Subject: Notice of design Change for LQ084S3LG03

- Model : LQ084S3LG03
- Content : The production plant of a LCD panel is changed.  
The material of the cover is changed.  
The thickness of Tape is changed.
- Reason : Stable supply of LCD module
- Schedule : Sample : 2022/02~  
RTR : 2022/05~  
Approval : 2022/06~  
MP : 2022/10~
- Specification and reliability :  
There is no change in the reliability and specification.
- Others :  
Please refer to table ①.

◆COVER

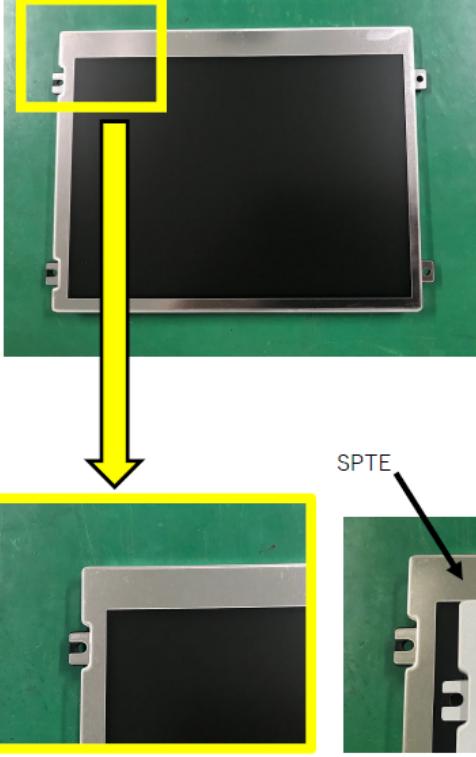
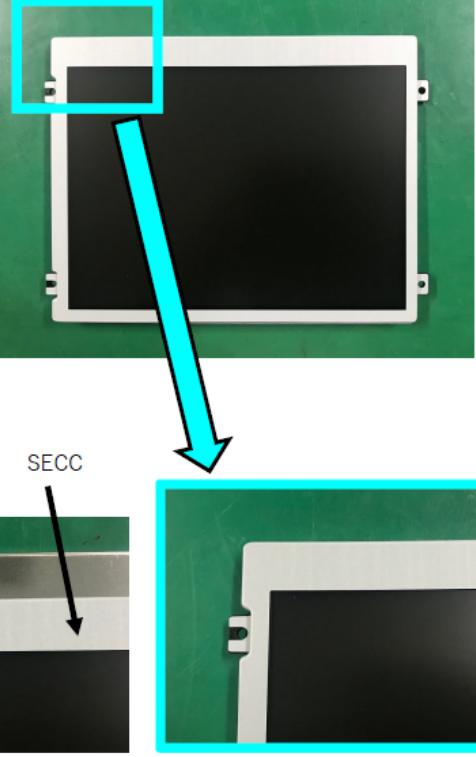
CURRENT/現行	CHANGE/変更後
TYPE	SPTE/プリキ	SECC/電気亜鉛メッキ鋼板
APPEARANCE /外観

◆PWB COVER

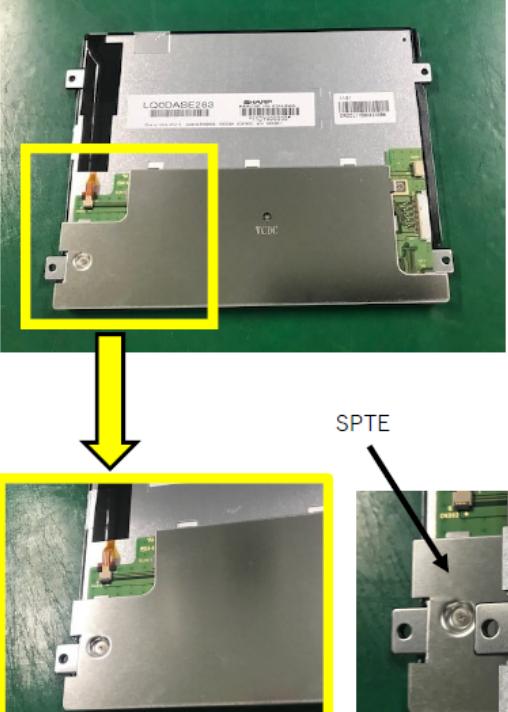
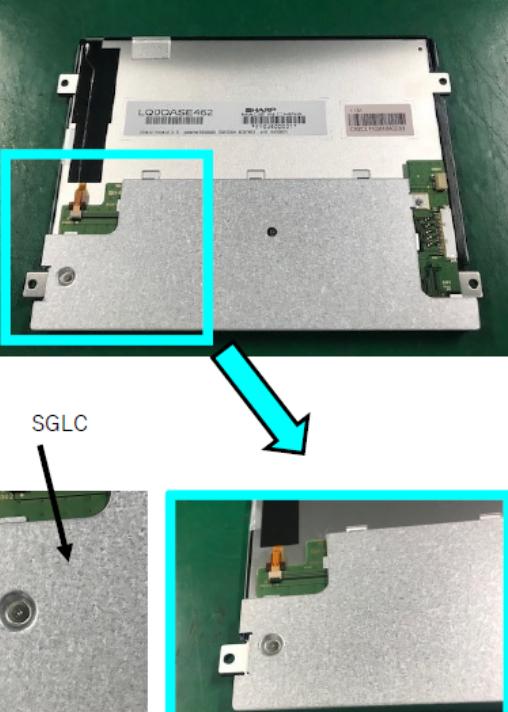
CURRENT/現行	CHANGE/変更後
TYPE/材料名	SPTE/プリキ	SGLC/溶融アルミメッキ鋼板
APPEARANCE /外観
